# City of Surrey PLANNING & DEVELOPMENT REPORT File: 7914-0024-00

Planning Report Date: June 23, 2014

#### PROPOSAL:

- LAP Amendment for a portion of the site from Garden Apartments (30 upa) to Apartments (55 upa)
- Rezoning from RF and RM-D to CD (based on RM-30 and RM-45)
- Development Permit

THE REP 2W 10000 DC4 248 BUILDING 1

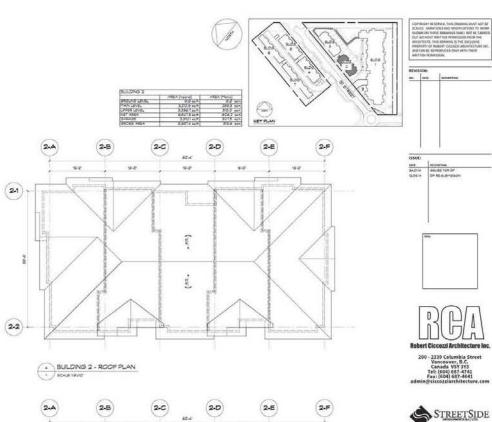
- Building 1 Apartment:
  - o Address the scale of the large east elevation with some "big" moves as opposed to repetition of a series of small moves.
  - o Consider more major articulation and or a distinct change of expression in the centre of the street façade.

The scale of both buildings are broken down through the use of strong projecting vertical and horizontal forms that are further articulated with extended roof overhangs and wood brackets, assisted with the placement of the materials and colours. The projecting forms not only help reduce the scale of the building but also provide relief through a strong vertical rhythm along the horizontal length of the building.

ally:	RC RC
145454	PRESENTANI RCA288
BUIL ELEV	DING 4 ATIONS

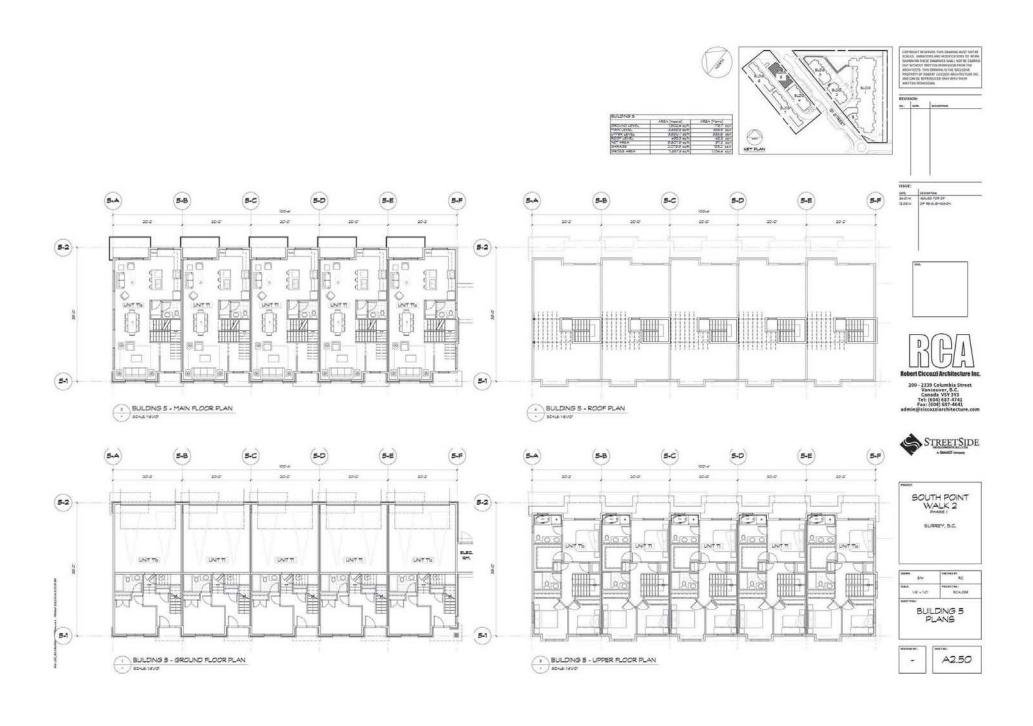
- Brownstone townhouses extended roof decks to 4th level. Introduced a trellis feature.
- Drawing A2.41 Roof top Elevation at Townhouse stair elements extended up the width of the stair and shade element added.

The stairways in the brownstone townhouses have been extended up to the roof decks as a one storey built form with extended roof over hangs and incorporating a strong trellis extending the width of the townhouse to provide some shade for the roof deck. The drive isle on the West parcel will also be enhanced with a stamped/textured treatment in key locations to introduce a more pedestrian friendly appearance. The material palette proposed for the brownstone townhouses is consistent with the palette applied to the other buildings in the project. Roofs for Buildings 6 and 7 (the pair of buildings nearest the West property line) have been simplified with a hipped 4/12 sloped roof to integrate better with the rest of the project.
